SECTION 00 91 03

ADDENDUM NO. 3

CSM Bldg 2,4 Mod. Project
Bid #86573

Addendum 3

AD3-A.5

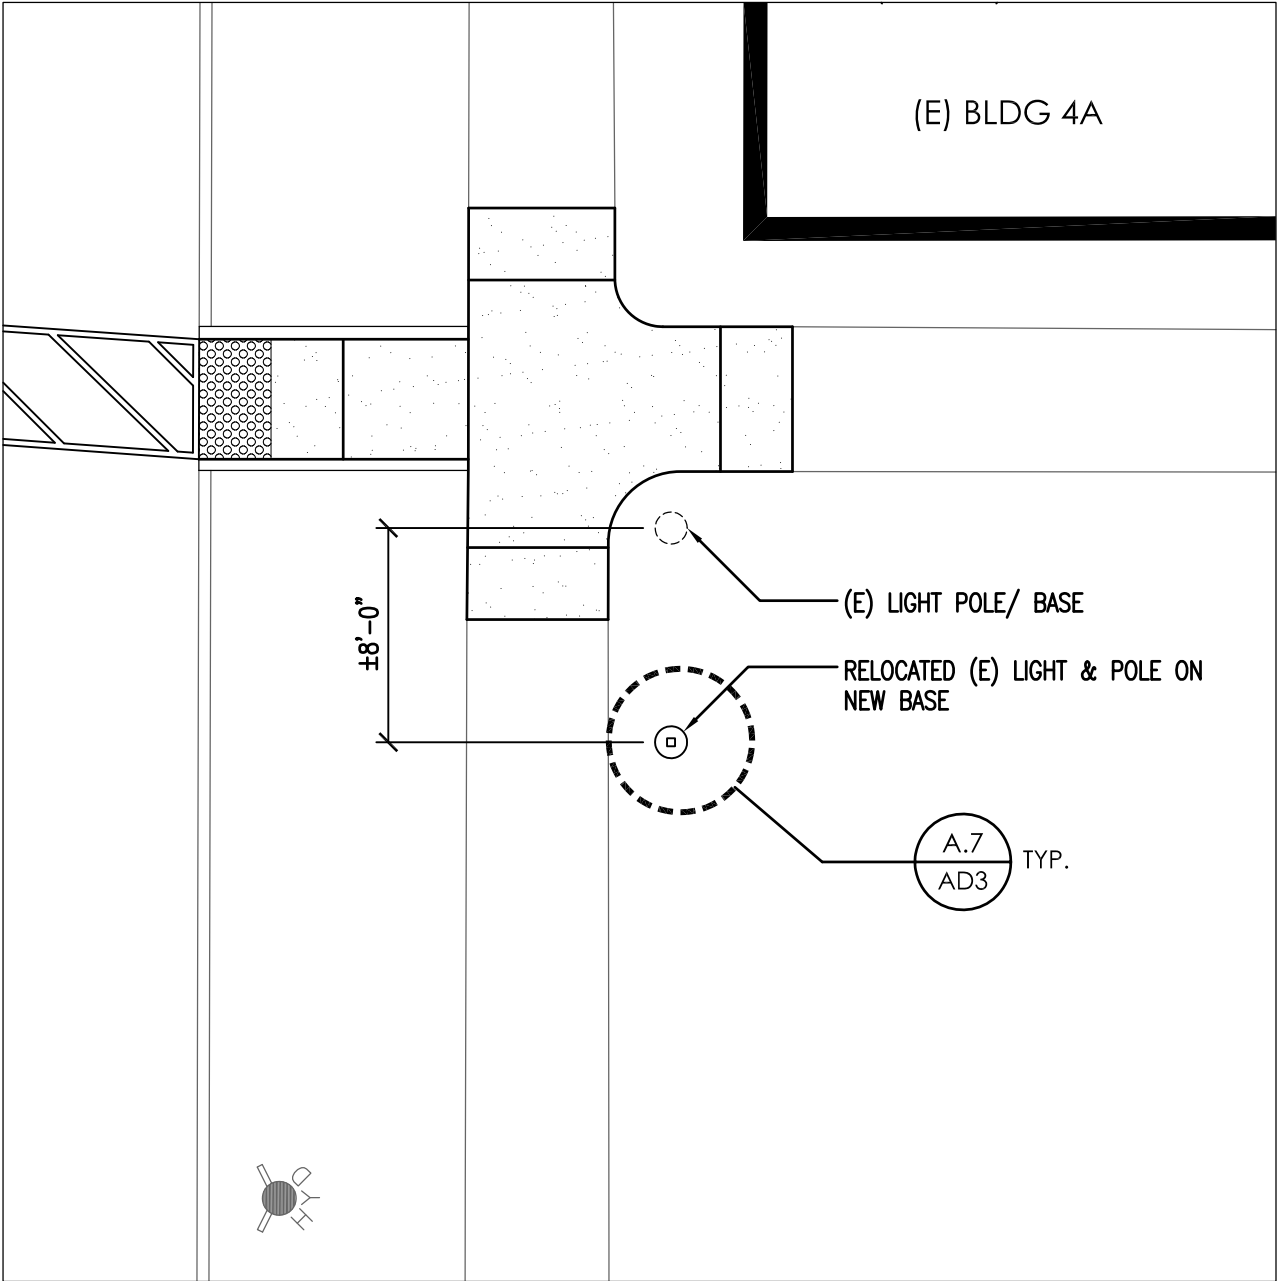
2. REVISE door schedule entries as shown on attached Drawing AD3-A.5 (includes addition of Door 154B).
D/A16	A-750	<ol style="list-style-type: none"> 1. REVISE General Note “C” to read: “Paint both (E) and replacement 12x12 acoustic tiles with non-bridging paint at ceilings and walls scheduled for painting which include areas of 12x12 acoustic tile.” 2. REVISE the following scheduled Room Finishes: <ol style="list-style-type: none"> a. Room 150 to “Sealed Concrete”(floor); b. Room 151 to “Sealed Concrete” (floor); c. Room 253 to “Resinous” (floor & base cove); d. Room 263 to “Resinous” (floor & base cove); 3. ADD the following room and finishes to the Room Finish Schedule: <ol style="list-style-type: none"> a. Room 153 – Office: Lino (floor); R (base); ES (walls); (E) A.C.T./ C (Ceiling Substrate); NBF (Ceiling Finish); Varies (ceiling height); 1 (remarks).

AD3-A.6

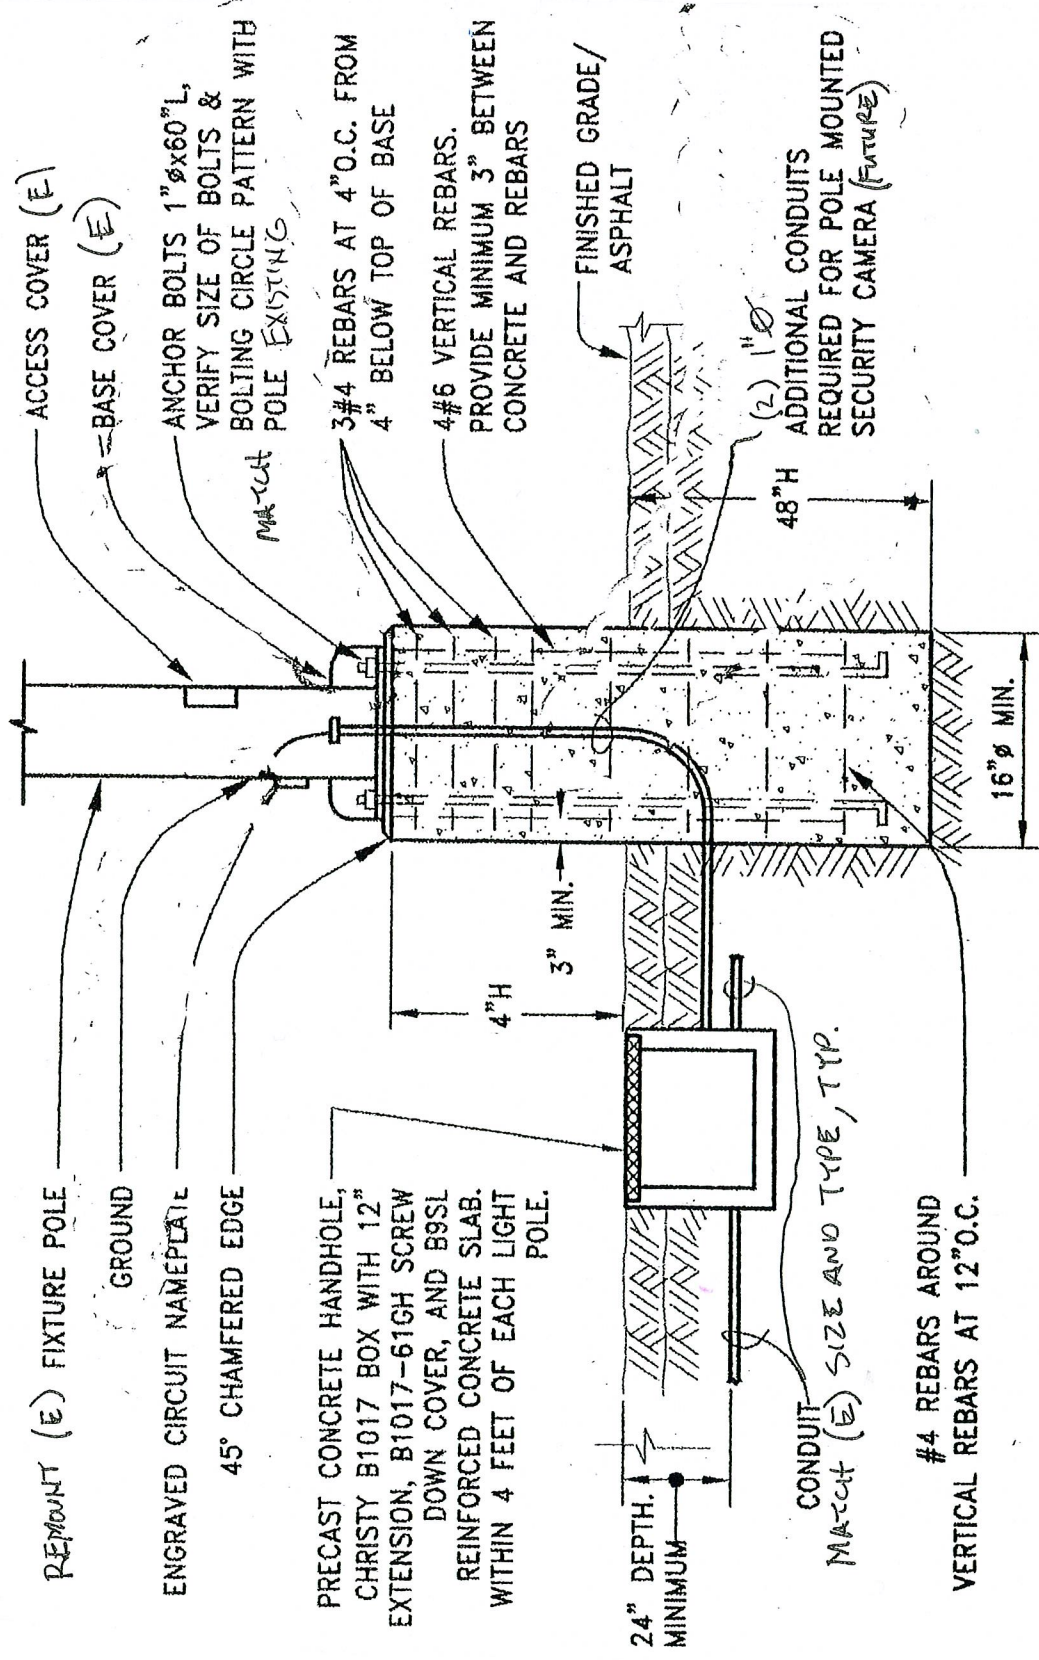
Item No.	Reference	Description
D/A1	Drawing A-110	REVISE: Details B, C2/A-110 to show (e) walkway light pole removed and relocated to a position approximately 8'-0" south of present location, per attached Detail AD3-A6 ADD: attached Detail AD3-A.7 (Light Pole Base and Handhole) to position B1/A1-110
D/A2	Drawing A-112, A-130, A-132 Retain this scope as part of Addendum 2, Bid Item 6, Alternate 3	1. DELETE Details C2, C3/ A-112 for Manufactured Entry Landings, and references to these details from Sheets A-130 & A-132 (entry landings to Courtyard level to be addressed by on-going design/build project, under separate contract at the campus). 2. DELETE references to Details C2, C3/ A-112 from Sheets A-130 & A-132, and cross-hatched areas at door entries indicating manufactured entry landing work.
D/A3	Drawing A-120	REVISE: Sheet note D6 to read: “REMOVAL OF (E) 12x12 ACOUS TILE FROM WALLS AND CEILING BY OWNER'S ABATEMENT CONTRACTOR, UNDER SEPARATE CONTRACT”

AD3-M.1

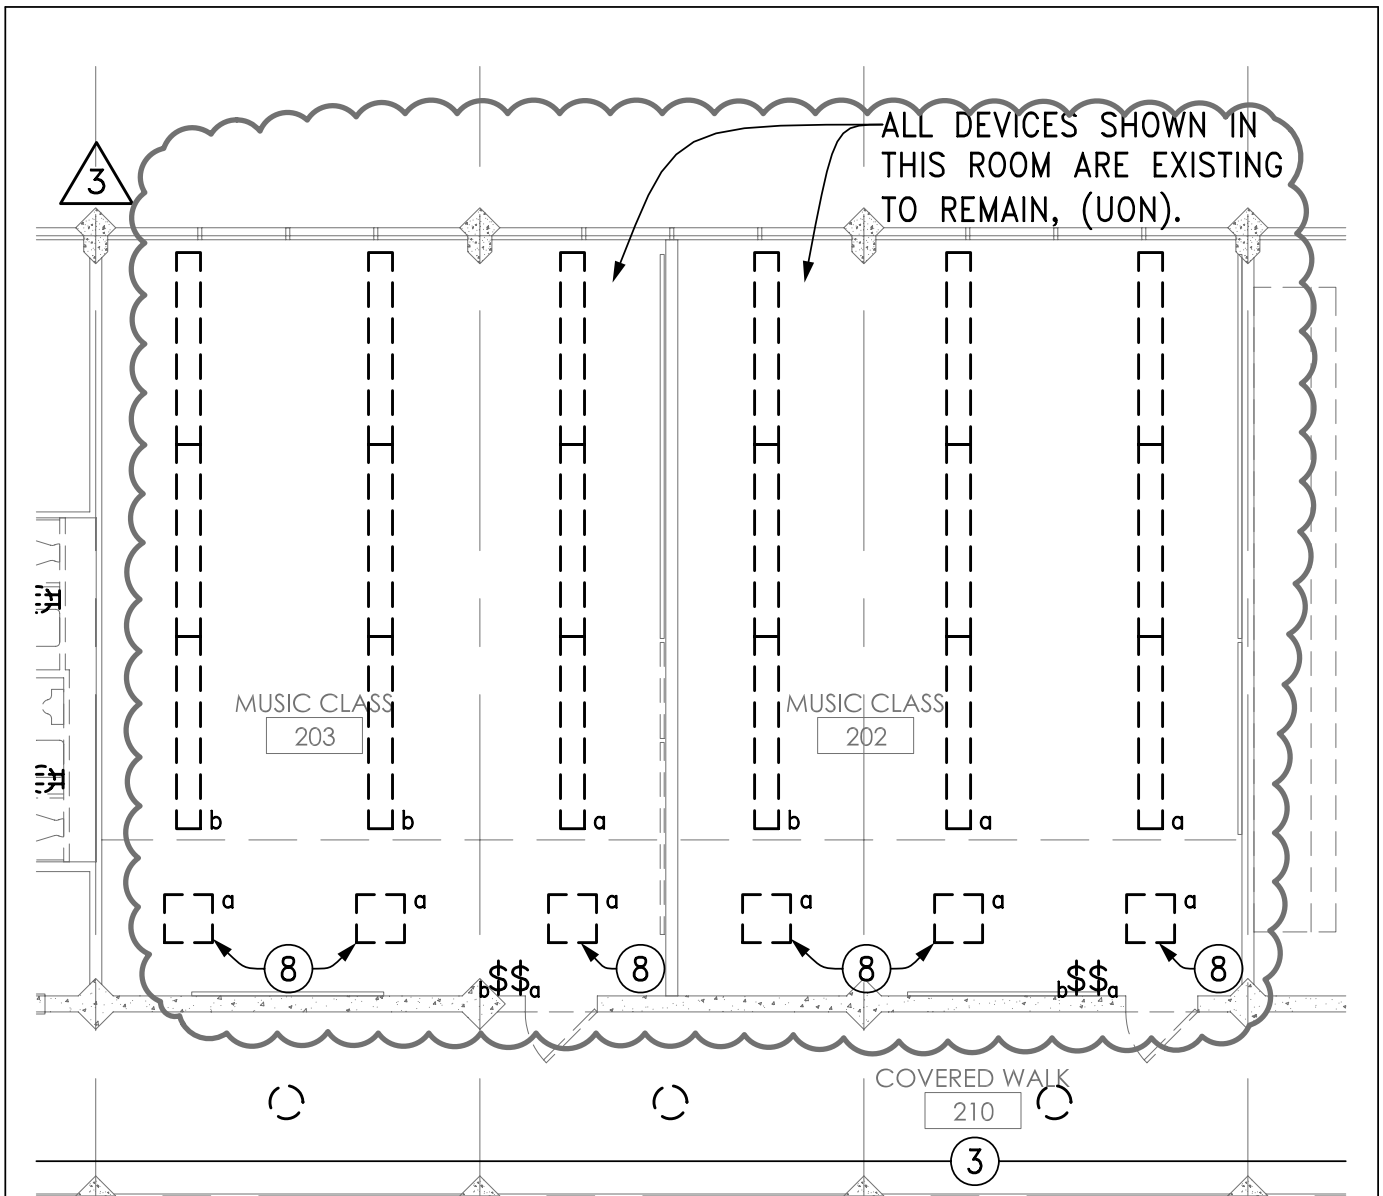
Item No.	Reference	Description
D/M1	Drawing M-002	1. ADD Heating Coil/HV Schedule, per attached SK-M-1

1. REBALANCE ALL AIRFLOW AT REGISTERS AND COIL.
2. REPLACE BELT AND SHEAVES AS REQUIRED TO ACHIEVE AIR BALANCE.
3. CONTROL TWO COILS WITH ONE ROOM THERMOSTAT.
4. FIELD VERIFY 2W OR 3W CONTROL VALVE PRIOR TO ORDERING. MATCH EXISTING TYPE.
5. PROVIDE PIPE TRANSITION TO CONTROL VALVE AS REQUIRED.

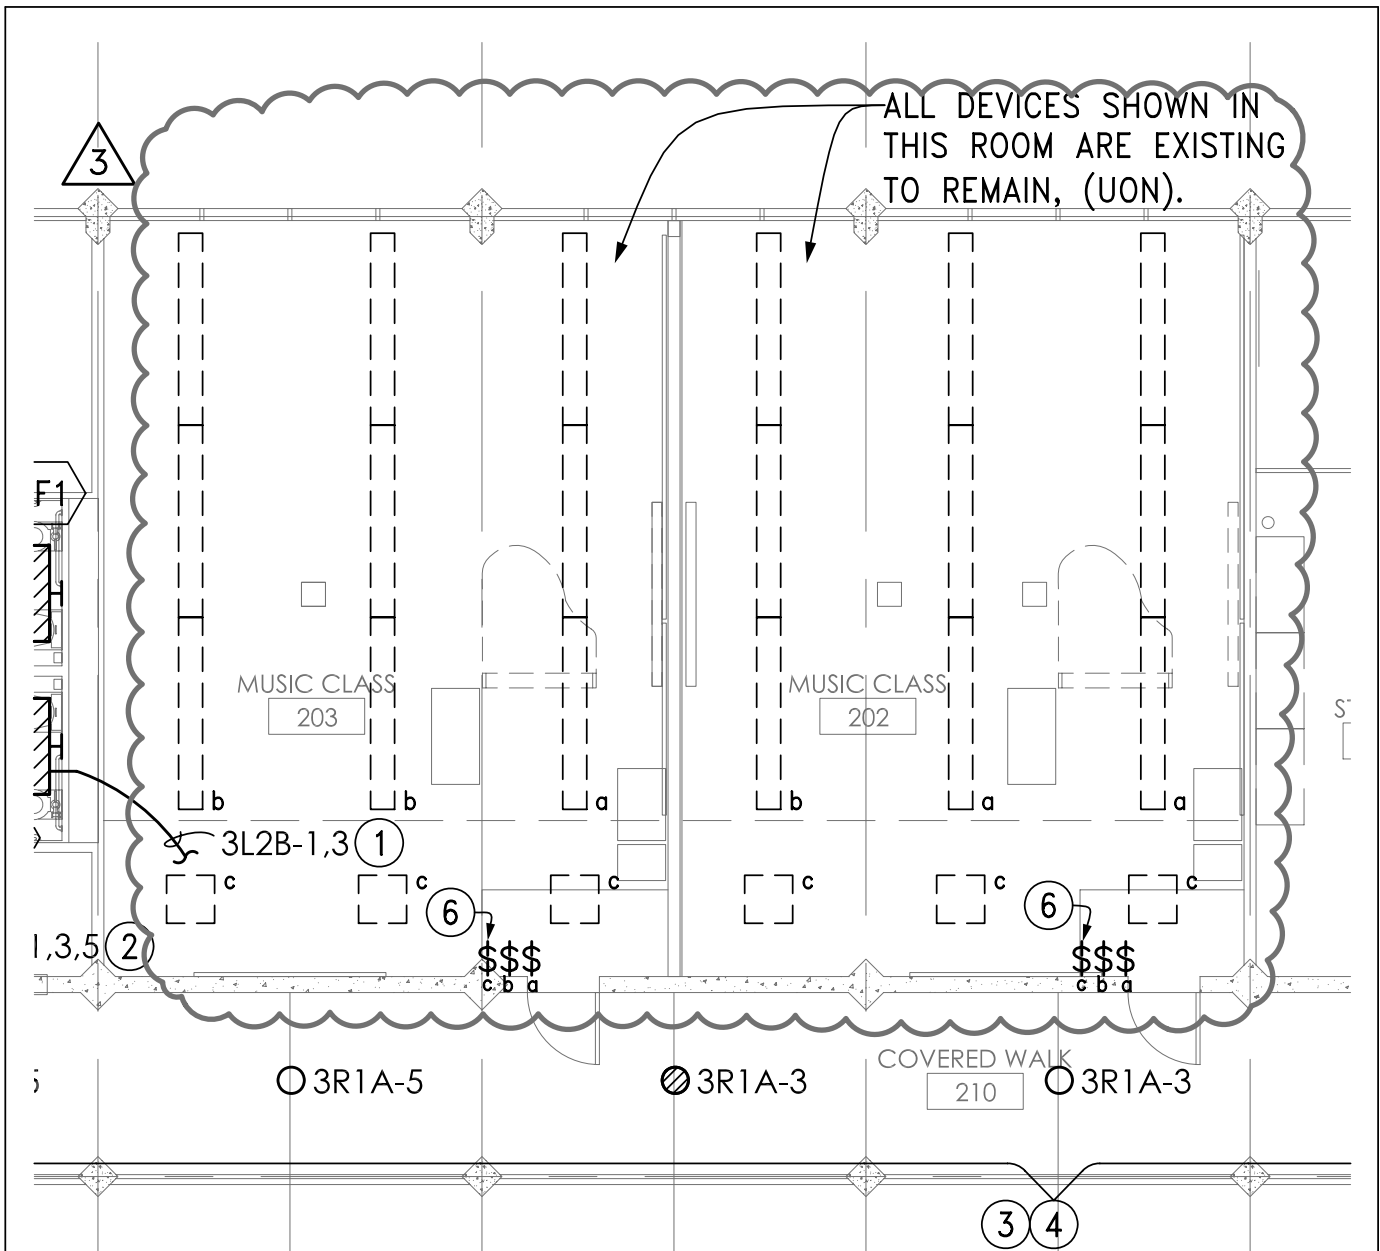
<ol style="list-style-type: none"> In room 202 and 203, ADD existing lighting to show scope of work. ADD Sheet Note No.8
D/E2	Drawing E-131	Detail B1 and C1 <ol style="list-style-type: none"> In room 150, 151, 152, 160, 250, 251 and Dark Rooms, ADD existing lighting to show scope of work. ADD Sheet Note No. 10 to 15.
D/E3	Drawing E-230	Detail C1 <ol style="list-style-type: none"> In room 202 and 203, ADD new switches. ADD Sheet Note No.6
D/E4	Drawing E-231	Detail A1 and C1 <ol style="list-style-type: none"> In room 150, 151, 152, 160, 250 and 251, ADD new switches. In Dark Room, ADD relocated light fixtures and switches. ADD Sheet Note No. 8 to 12.
D/E5	Drawing E-331	Detail A1 <ol style="list-style-type: none"> In room 151 and 160, ADD ceiling mounted receptacles. In room 160, ADD dimmer bank. ADD Sheet Note No. 11 to 14.
D/E6	Drawing E-400	Detail C1 <ol style="list-style-type: none"> ADD detail C1 to show fire alarm work in Dark Room. ADD Sheet Note No. 3.

8 DISCONNECT LIGHT FIXTURE FROM EXISTING SWITCHING ARRANGEMENT AND RECONNECT TO NEW SWITCH "c" AS INDICATED ON NEW PLAN.

drawing no.
AD3-SE.1

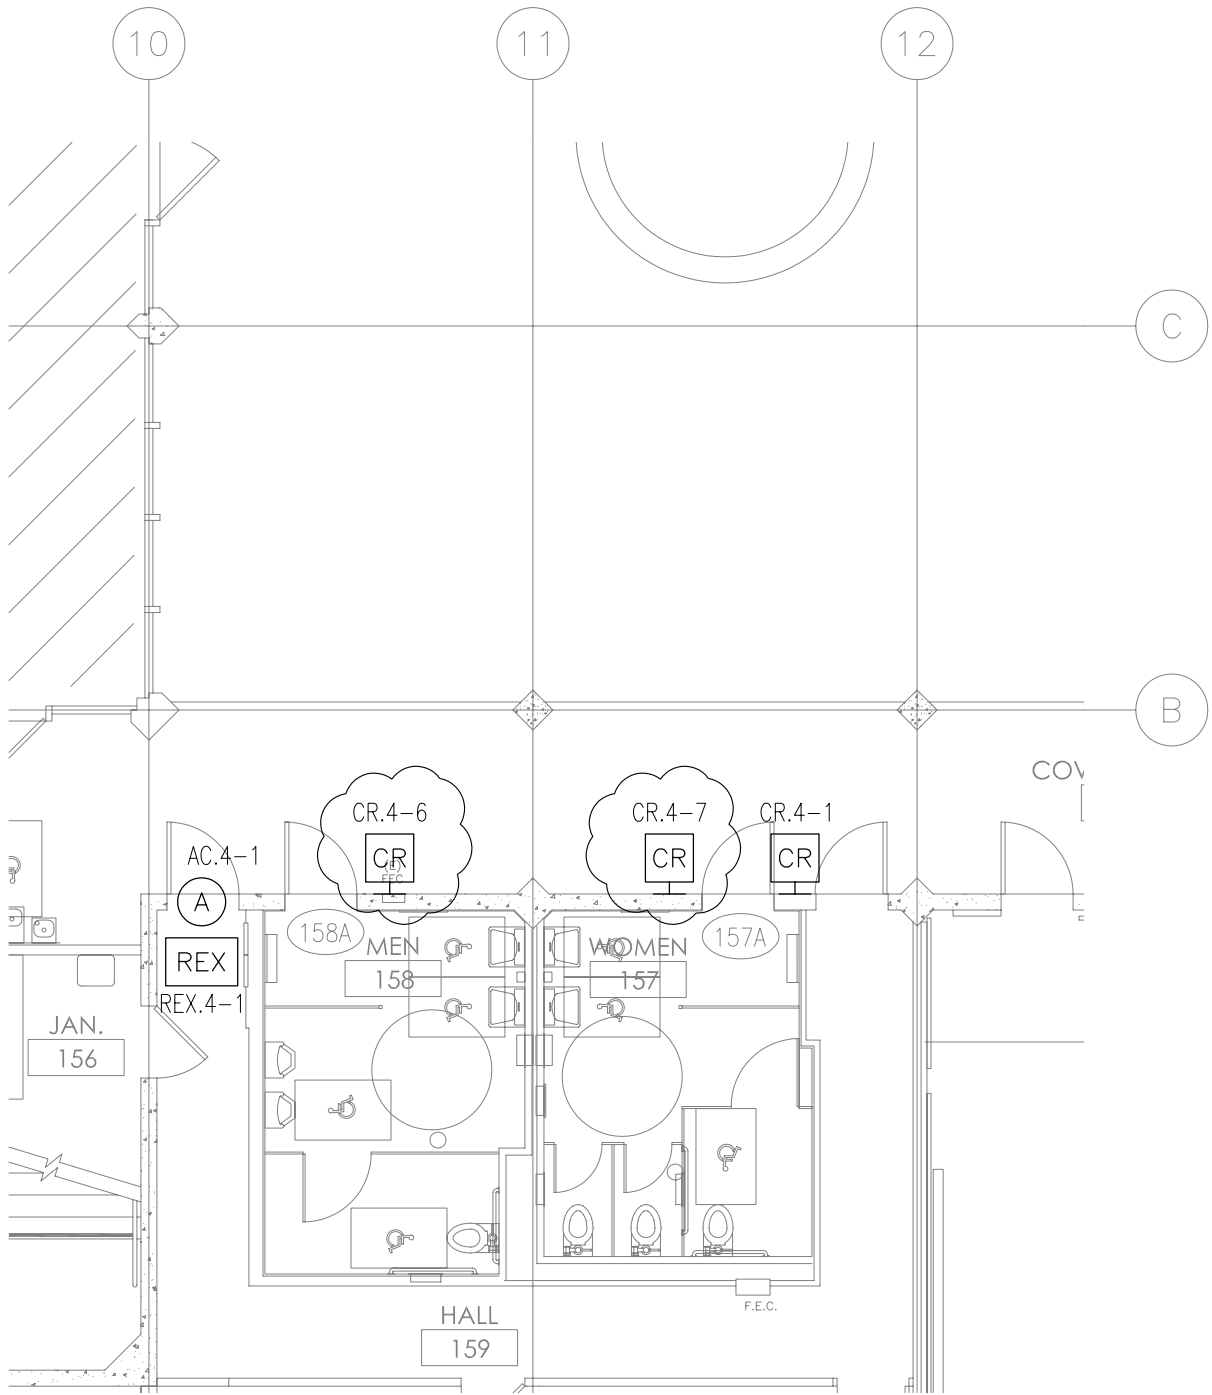
Item No.	Reference	Description
D/SE1	AD.3-SE.1	<ol style="list-style-type: none"> Provide Card Reader, Request-to-Exit Device, and Door Alarm Contact at door 135A. Connect to Access Control System. Provide Card Reader, Request-to-Exit Device, and Door Alarm Contact at door 137A. Connect to Access Control System.
D/SE2	AD.3-SE.2	<ol style="list-style-type: none"> Provide Card Reader, Request-to-Exit Device, and Door Alarm Contact at door 157A. Connect to Access Control System. Provide Card Reader, Request-to-Exit Device, and Door Alarm Contact at door 158A. Connect to Access Control System.
D/SE3	AD.3-SE.3	<ol style="list-style-type: none"> Provide Card Reader, Request-to-Exit Device, and Door Alarm Contact at door 254A. Connect to Access Control System. Provide Card Reader, Request-to-Exit Device, and Door Alarm Contact at door 261A. Connect to Access Control System.
D/SE4	AD.3-SE.4	<ol style="list-style-type: none"> Note revised Card Reader Schedule for Access Control System.
